EMERGENCY PREPAREDNESS EVALUATION REPORT

IN THE MATTER OF  
THE UNIVERSITY OF MICHIGAN  
MICHIGAN MEMORIAL-PHOENIX PROJECT  
FORD NUCLEAR REACTOR

LICENSE NO. R-28

JANUARY 1983

Figure 2

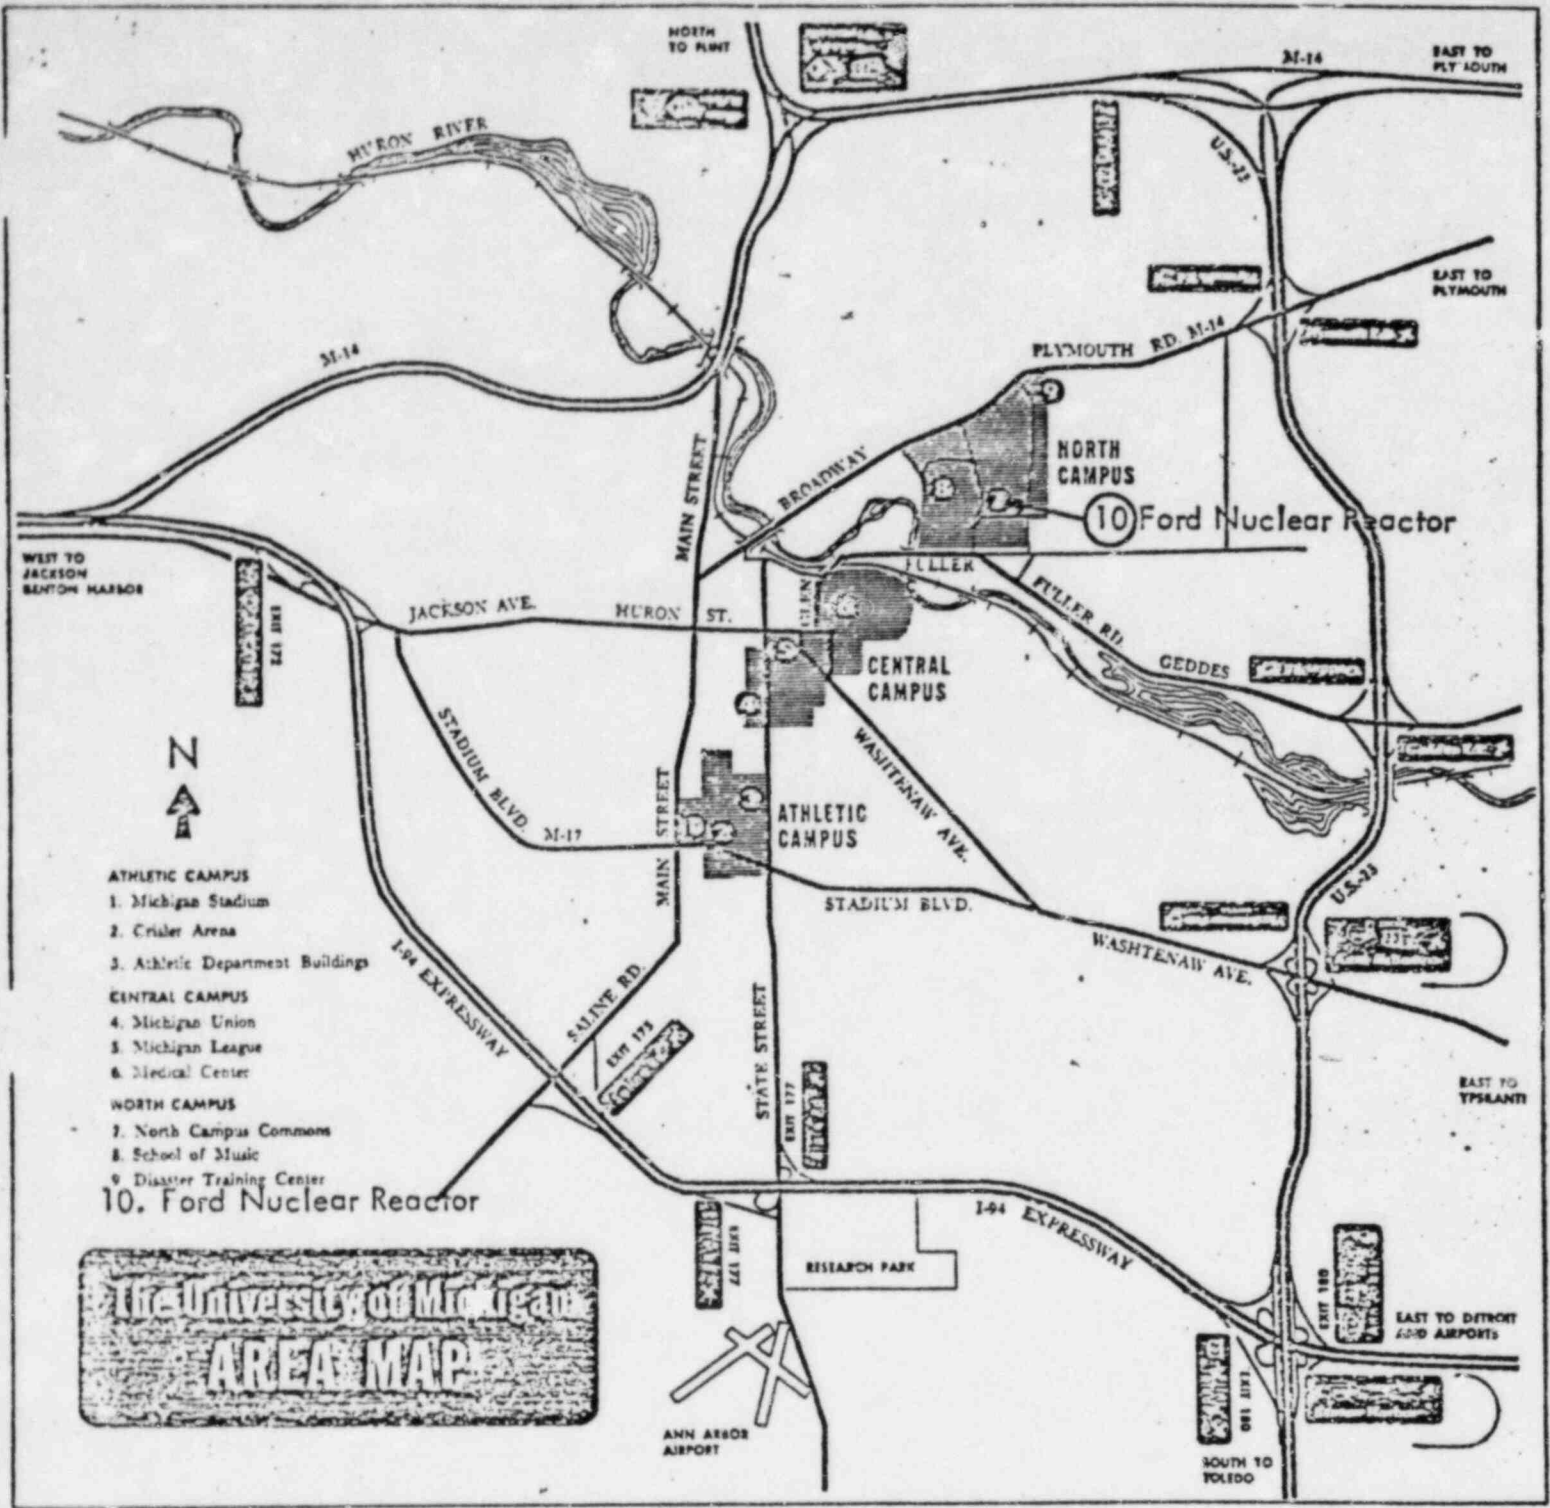
The plan does not specifically address or describe an Emergency Planning Zone (EPZ) for the FNR facility. The plan, in section 5.3 does establish a 1000 feet perimeter around the FNR facility (see Figure 2) as the site boundary for incident classification and evacuation.

This portion of the plan needs additional information for clarification and a finding of acceptability. This portion of the plan is not adequate.
